Authorized Field Change

AFC 06902

Subject: Valve Cover and Breather Upgrade for Certain International® 3200 and 4200 Models Built Between November 1, 2001 and December 31, 2002 with International® VT 365 Engines

Figure 1 Remove Studs and Bolts

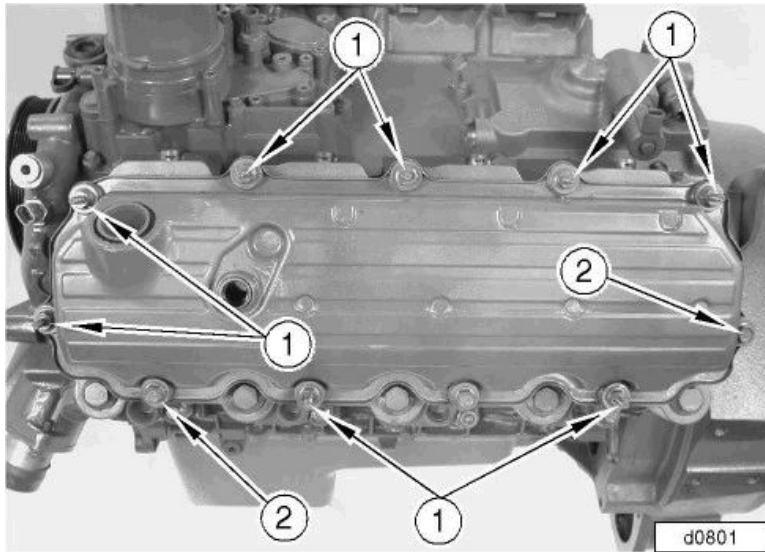
2. Disconnect the battery ground cable.
3. Remove the air cleaner housing with tube attached, disconnect the intake ambient temperature sensor (IAT), and ventilation tube from the valve cover.
4. Remove the electronic control module (ECM) with IDM and wiring.
5. Disconnect and remove the ECM wiring.
6. Remove the oil fill tube from the valve cover. Disconnect and remove the window washer reservoir from the mounting bracket.
7. Remove the exhaust back pressure sensor EBPS tube at the sensor.
8. Remove the ECM mounting bracket, disconnect the EBPS wiring, and remove the tube.
9. Remove the dip stick tube.
10. Disconnect the crankcase ventilation breather assembly and remove the remaining air duct from the turbocharger.
11. Remove the studs, bolts (Figure 1) and left valve cover.

- 12. Inspect the valve cover gasket and replace only if necessary and install the new valve cover onto the rocker arm carrier.
- 13. Install the valve cover mounting bolts and studs in the correct locations as shown in Figure 1. Leave the bolts finger tight until all bolts and studs are installed then tighten to 60 to 84 Lbf-in (7 to 9 Nm).
- 14. Install the new o-ring onto the breather pipe and install the new breather hose assembly and hose clamp.
- 15. Install the new air inlet duct to turbocharger.
- 16. Continue following Steps 1 through Step 9 in reverse order.
